**Re: 49900 Old Victory Road – REZONING AND PRELIMINARY PLAT
Response to Comments 2 – 07/18/23**

PLT2023-00011 PRELIMINARY PLAT COMMENTS:

OAK PARK ESTATES SUBDIVISION - PRELIMINARY PLAT CASE No.: PRC2023-00007

SHEET 2 OF 2

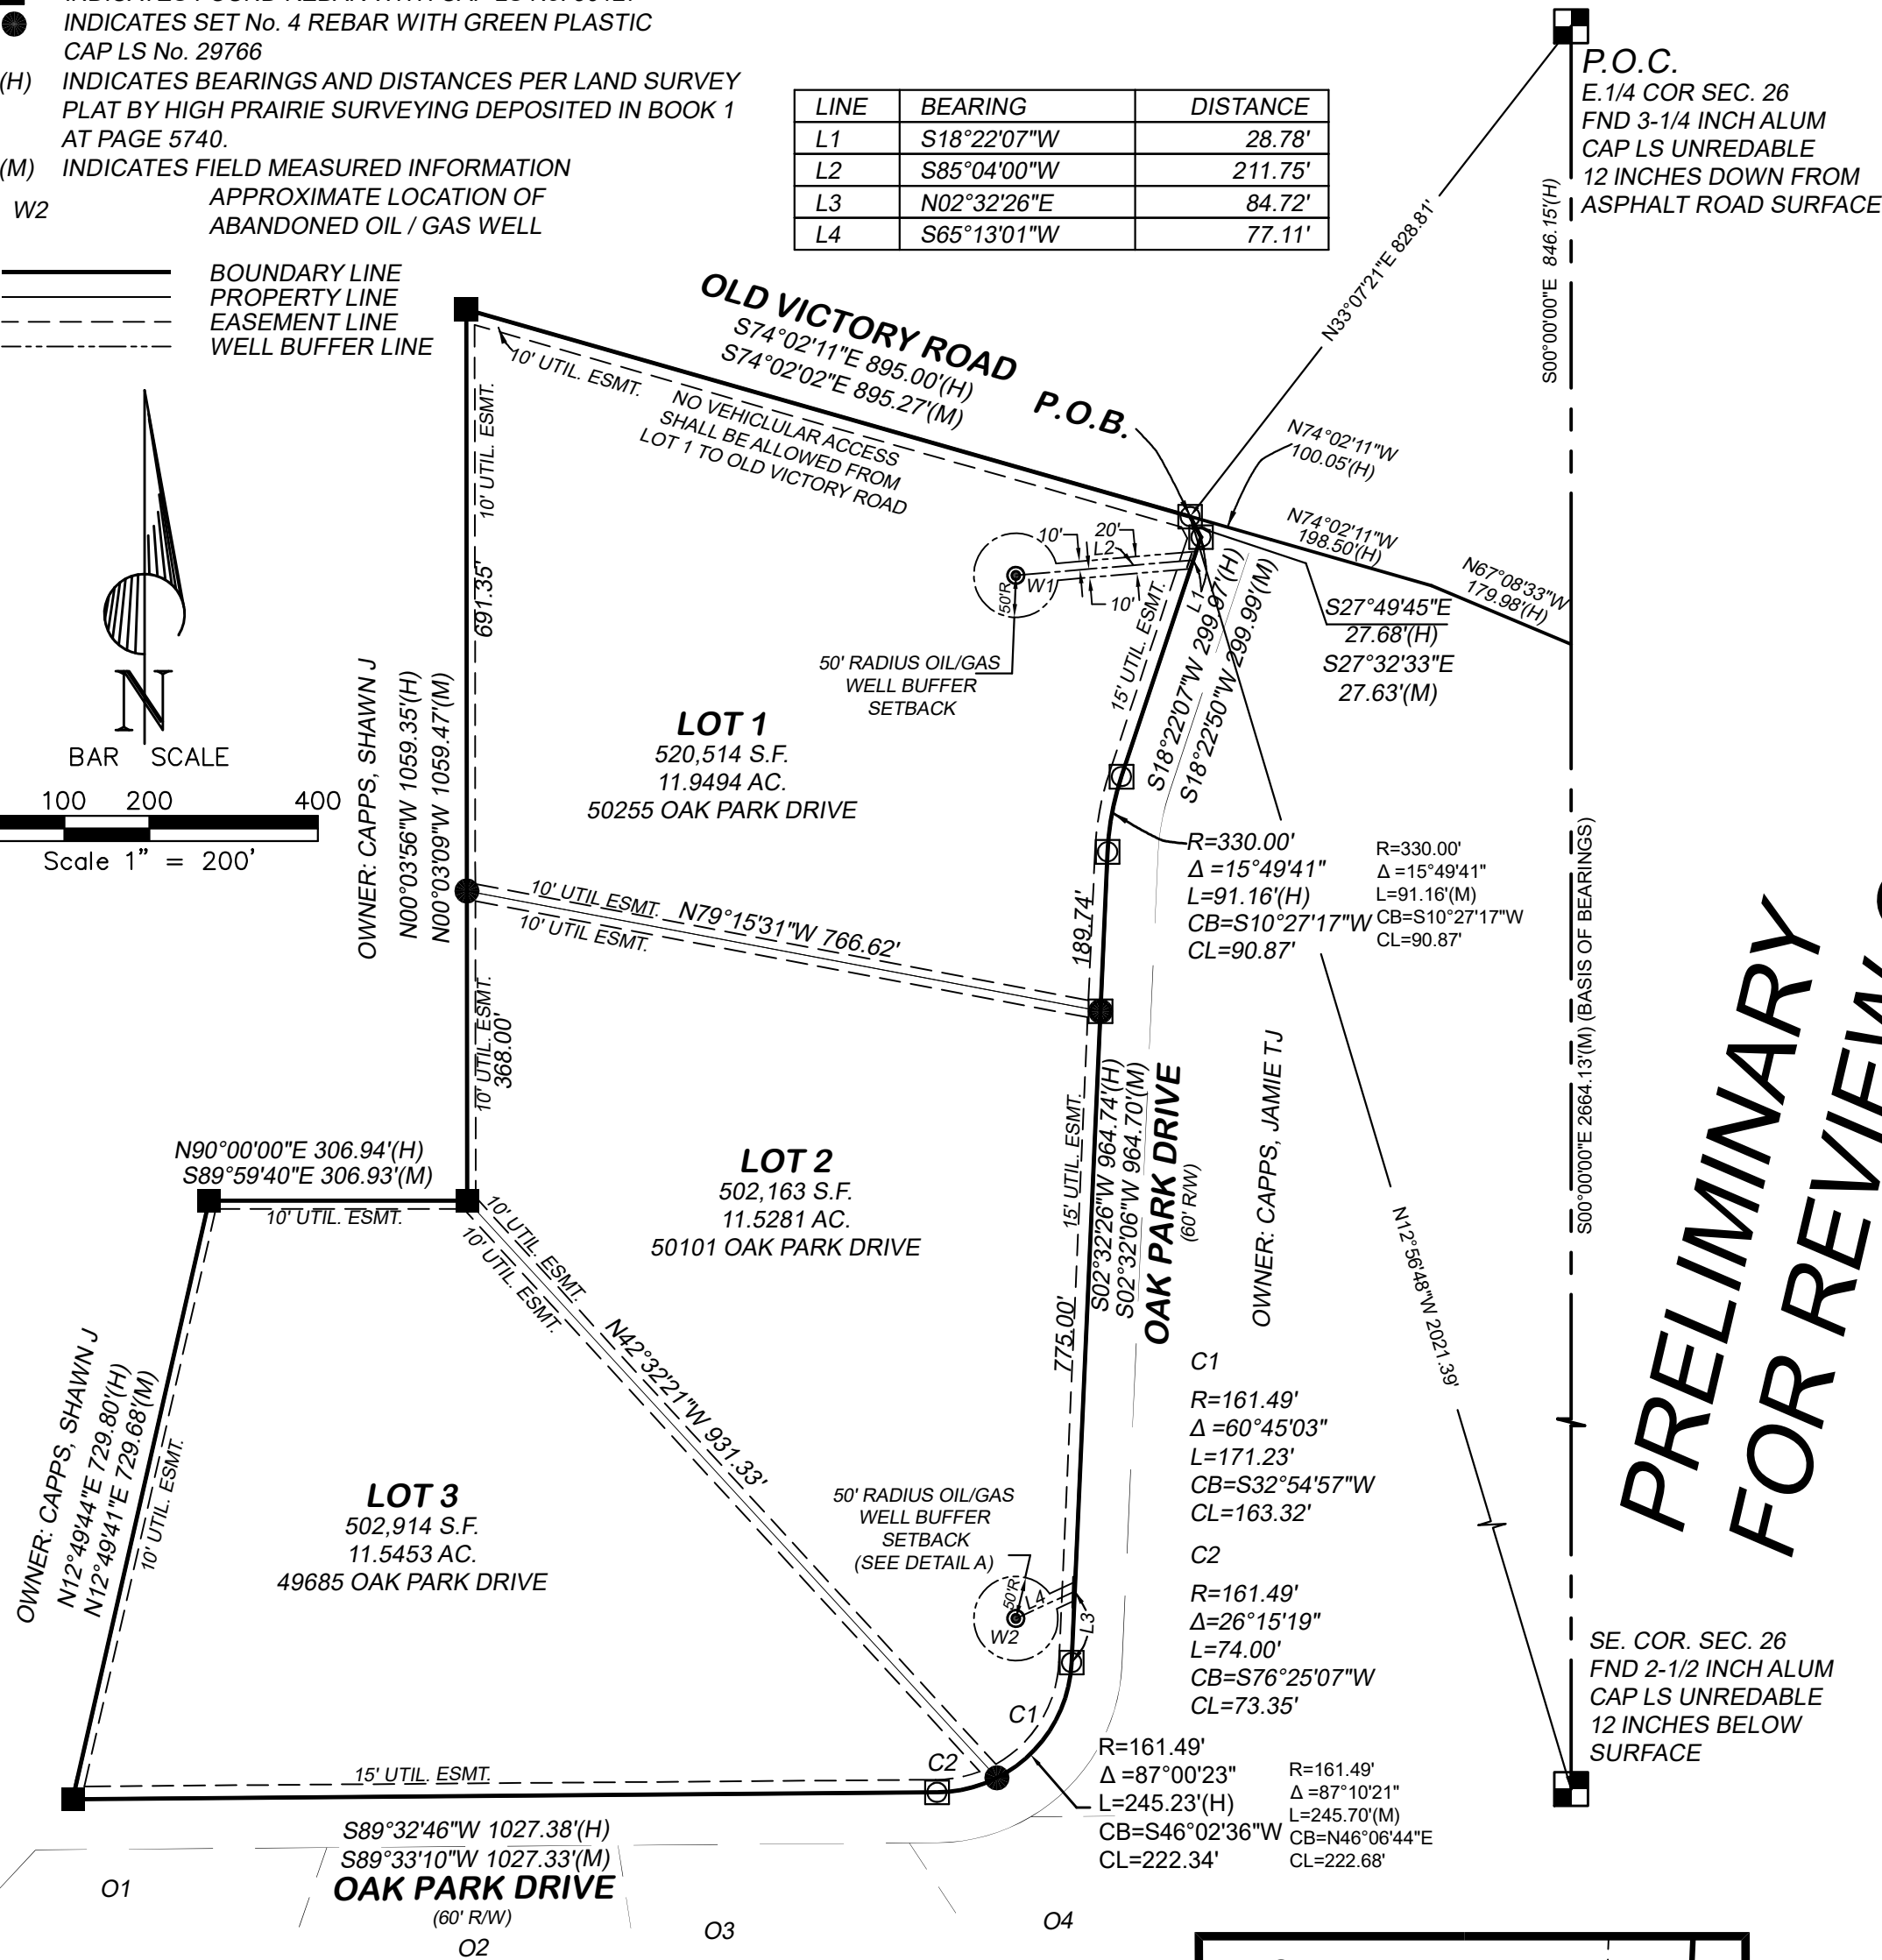
ROW1: Revise the m/b legal to correctly identify Oak Park Drive, not Road to remove the ambiguity caused by this reference.

ROW2: Revise Notary Acknowledgement to read: THE FOREGOING OWNERSHIP AND DEDICATION CERTIFICATE...

ROW3: Provide Basis of Bearings Note

ROW4: Notes are out of sequential order, revise.

ROW5: Need to possibly revise Note 8 (first one) due to revisions.

ROW6: Access provision note: No access from Lot 1 directly onto Old Victory Road

Revised

Revised

Added

Revised

Revised

Added

OAK PARK ROAD ESTATES
LEVEL III DRAINAGE PLAN

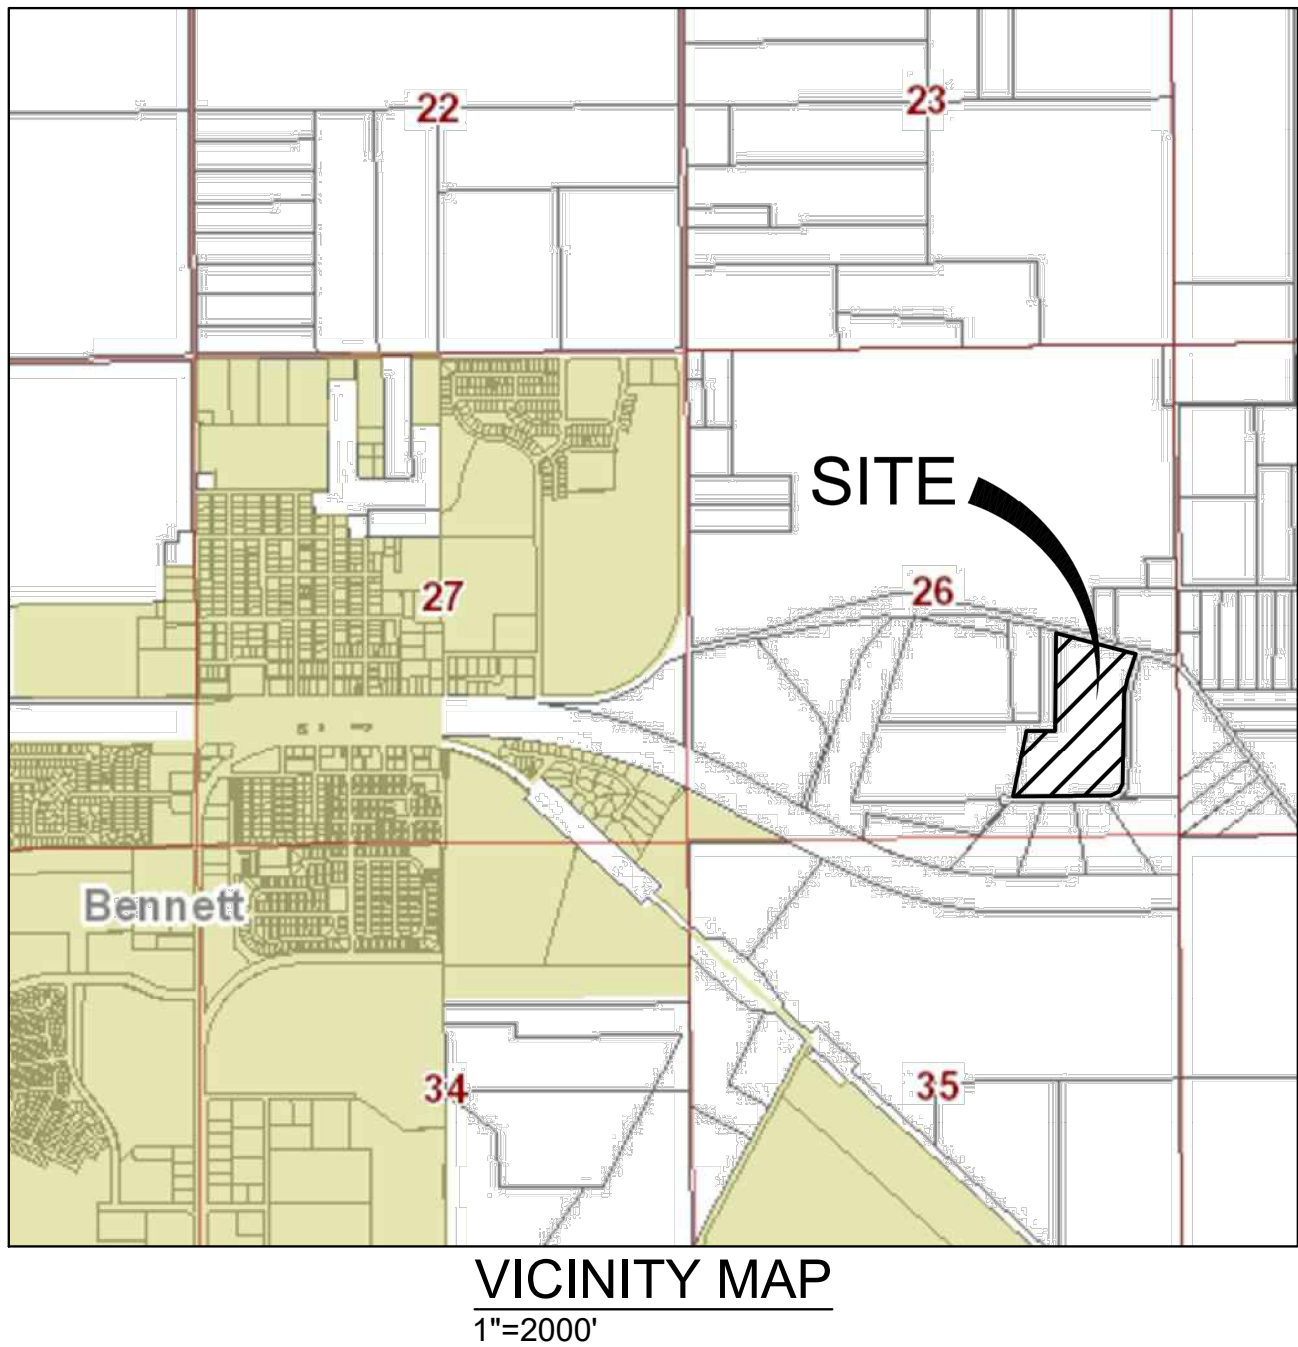
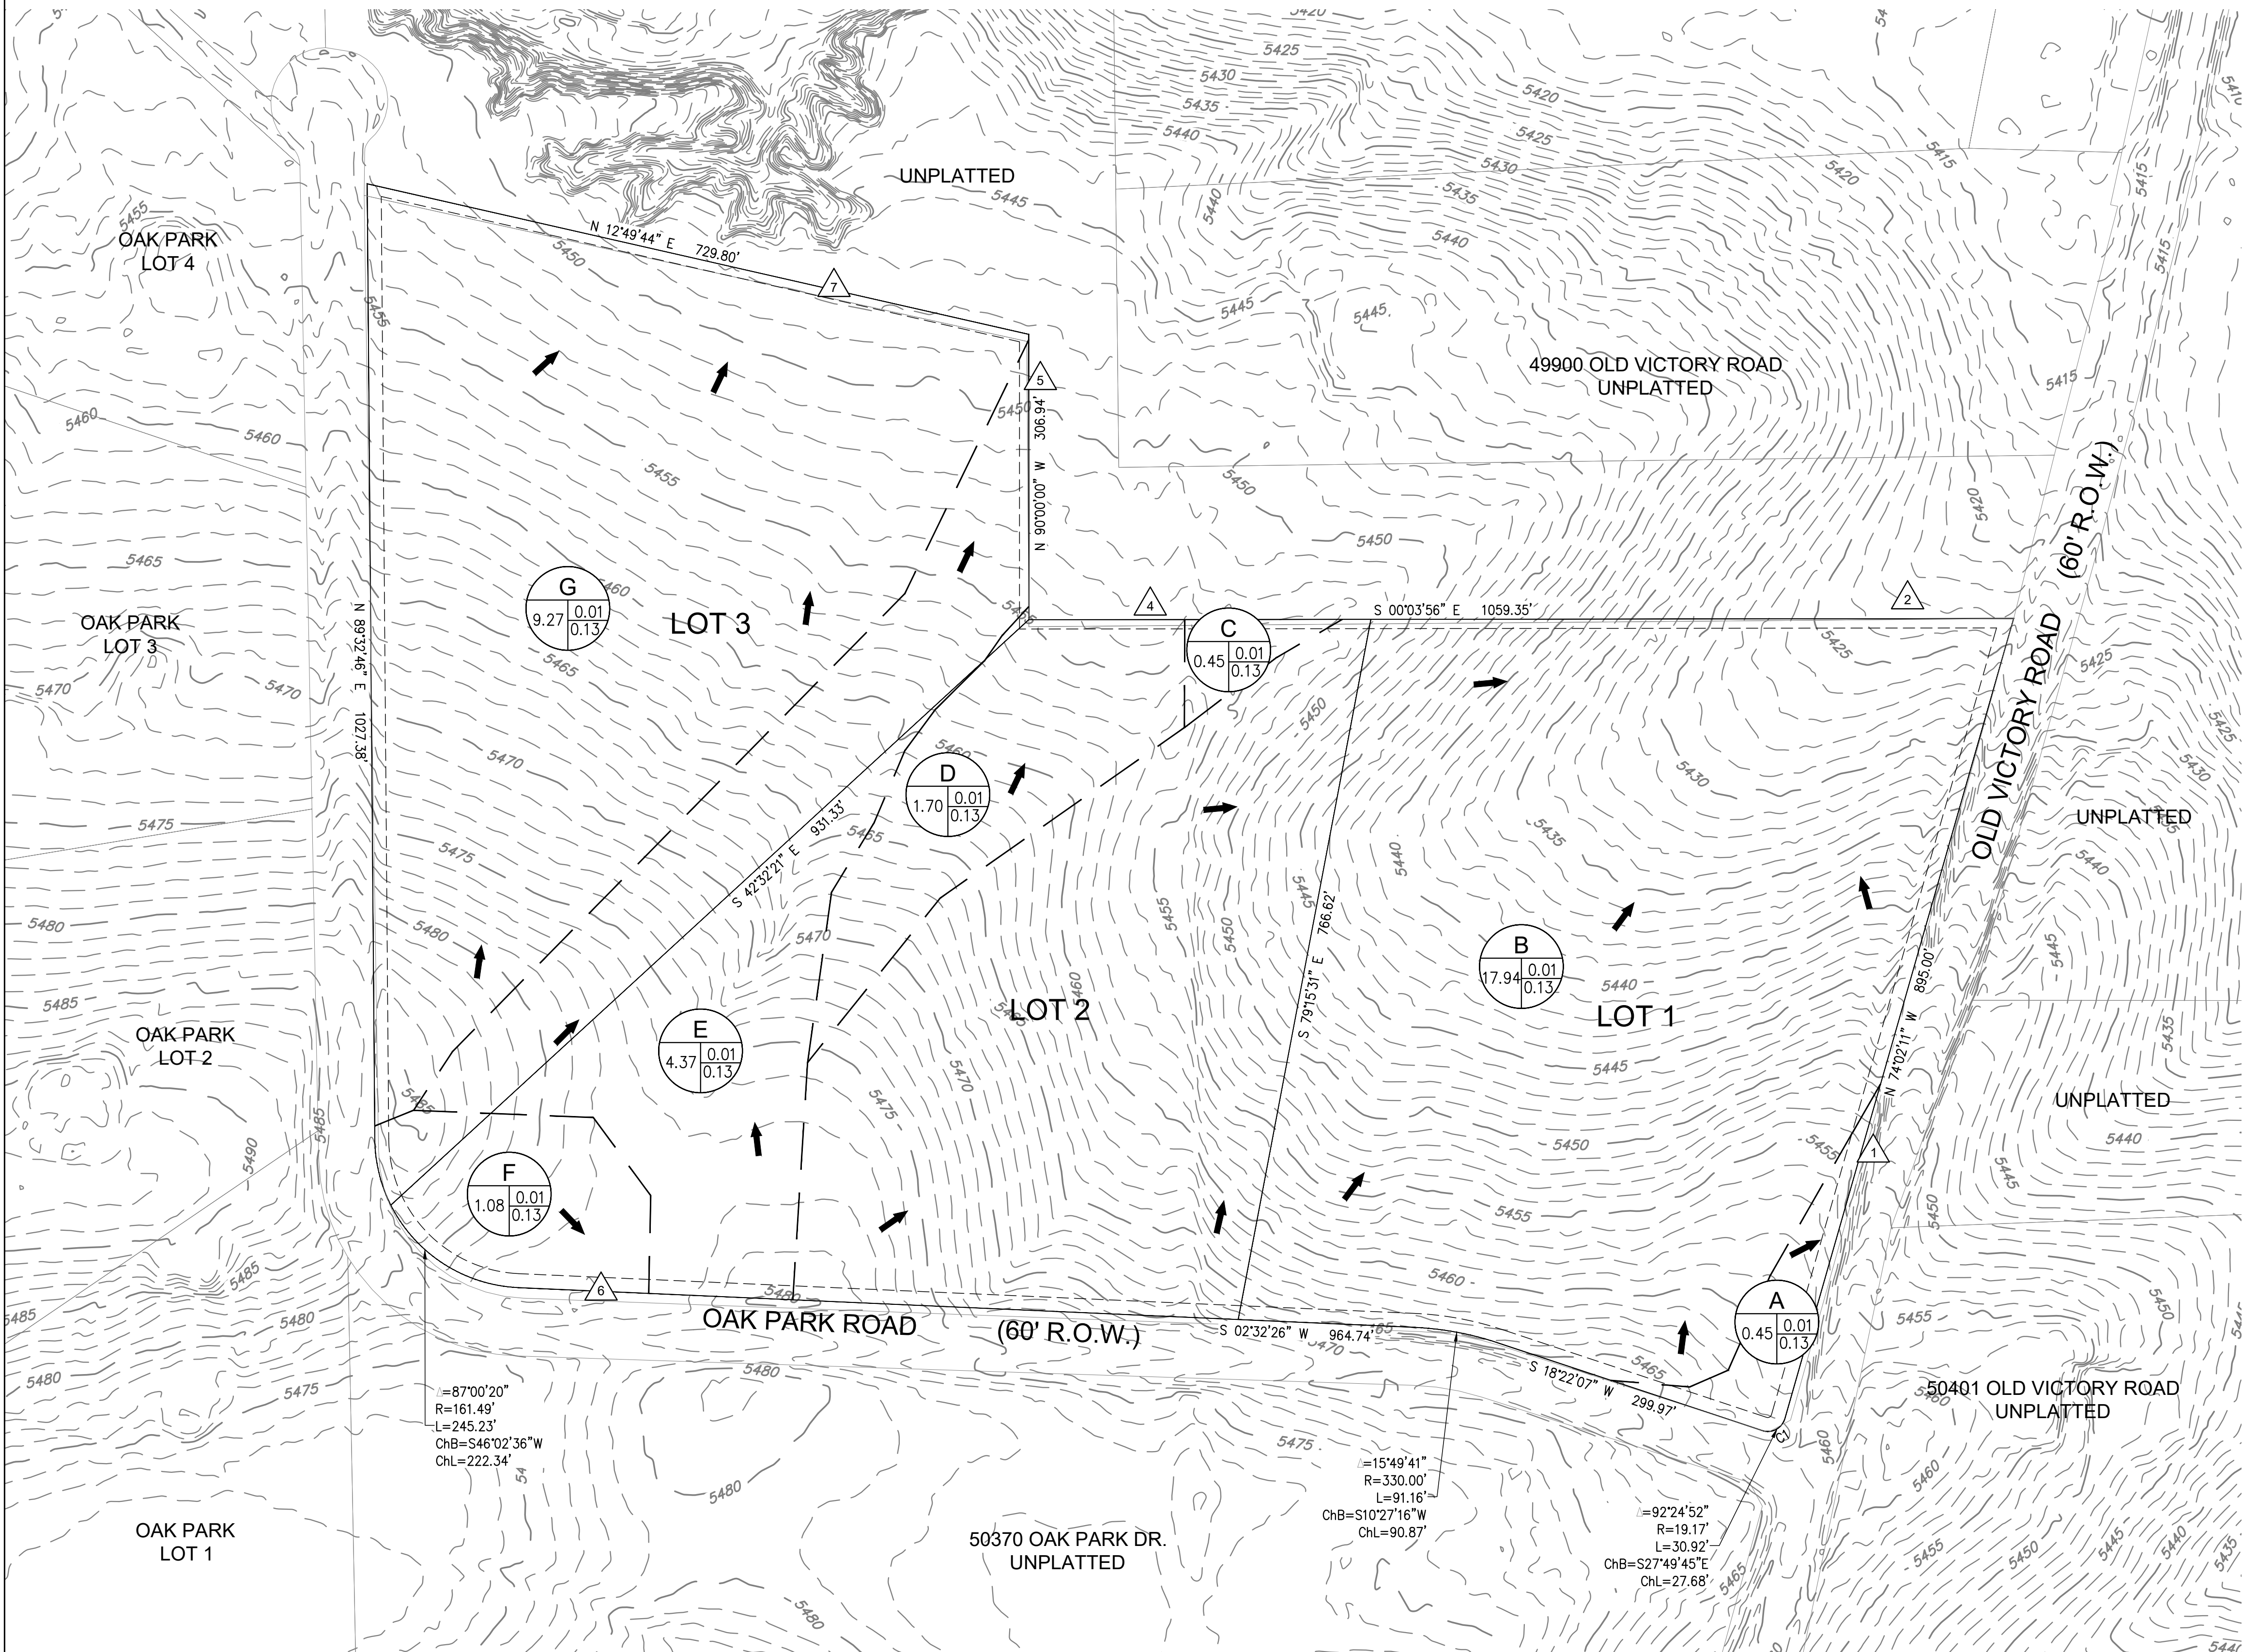
ENG8: The drainage report submitted indicate that the applicant does not intend to provide water detention or water quality. In response to the justifications given in the exemption request:

- The lot does NOT appear to be adjacent to Kiowa creek. There exists one property due west and three properties northwest between the site and Kiowa Creek.
- This request is NOT a residential lot split. A residential lot split results in two lots and this request results in three lots.

As a result, the applicant is still responsible for developing drainage infrastructure. However, the applicant may still qualify for detention exemption should the proposed developments be less than 5% of the total lot area.

In discussions with County staff prior to the drafting of the Drainage Report, it was noted that since the floodplain of Kiowa Creek encompasses nearly all of the adjacent lot to the west that the subject property could be considered adjacent to the floodplain, as it comes within a very short distance of the west property line. Additionally, because this is a minor subdivision with no roads, the concept of a lot split was applied in consideration of the detention exemption as this is a small minor subdivision project. Nevertheless, foregoing the two above exemption criteria, the project is developing far less than the 5% threshold for detention (~0.9%) and therefore does meet the exemption criteria. Calculations are shown in the drainage report.

Water quality treatment is included in the Drainage Report via Grass Buffers, a Mile High Flood Control District approved water quality treatment design option.
